City of Portland, Oregon
Bureau of Development Services
Land Use Services
 FROM CONCEPT TO CONSTRUCTION

2ND REVISED STAFF REPORT AND RECOMMENDATION TO THE HISTORIC LANDMARKS COMMISSION

CASE FILE: LU 15-262061 HR – Blake-McFall Renovation
 PC # 15-177711

EAST ELEVATION PROPOSED

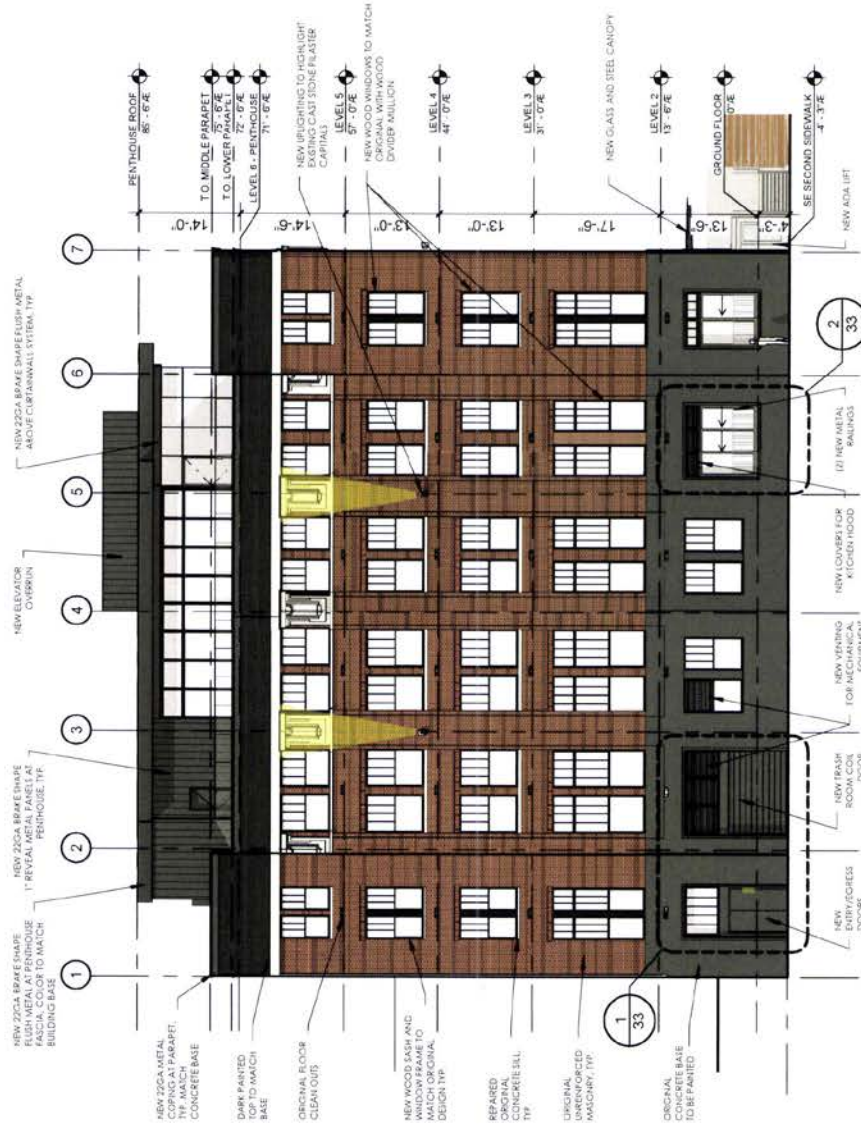
Staff notes that the northeast entrance was originally designed as the public entrance to the building, complete with glazed doors, transoms, and canopy. The applicant intends to remove the non-historic stucco and hopes to find the original transom windows hidden within the wall. In the first proposal, staff noted that the applicant intended to remove the function of the northeast entrance, and convert this access point to an egress with solid metal doors. Staff encouraged the applicant to maintain this entrance as a public entrance in order to carry this aspect of the building's history forward, particularly since the brick and window openings beneath the stucco are proposed to be restored; the applicant has since revised their proposal to maintain this entrance.
